DATE: 03/17/25
TO: All Bidders
FROM: David Cienfuegos, Purchasing Specialist
SUBJECT: Addendum 1 – Bid 705 Moorpark College ADA Parking Upgrades

Attached to this addendum please find attachments Concrete Curb Detail

C-501

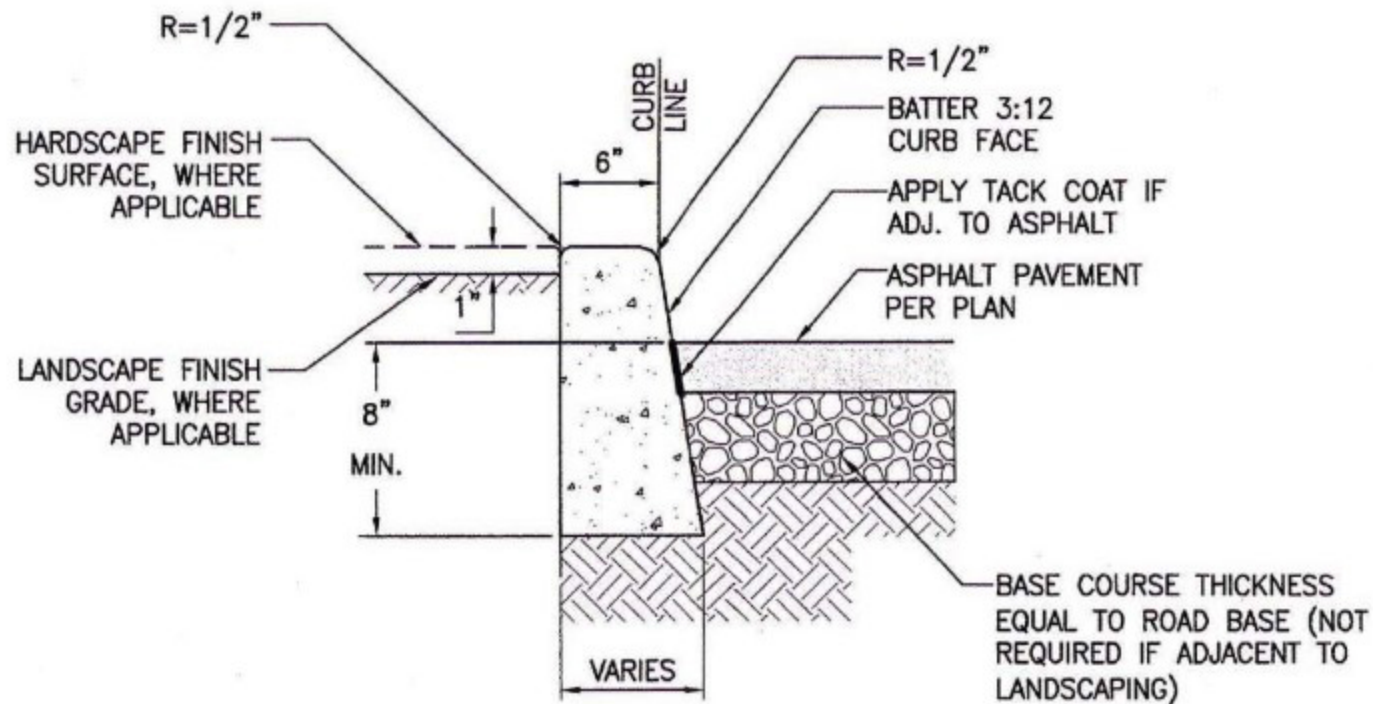
15. On the Fountain Hall parking plan, the plan shows a new ADA concrete ramp going in . On the job-walk, we were told that the existing ramp will be removed and our back with a curb face and sidewalk. Will a new drawing be provided?

- a. The ramp is to be removed and properly disposed of. The contractor shall provide a new 4 inch (normal) thick concrete sidewalk with #4 rebar @ 16" o.c. ea. Way, doweled a minimum of 6" into adjacent concrete. Concrete shall be reach a minimum of 2,000 PSI compressive strength in 28 days. Use attached detail for curb.
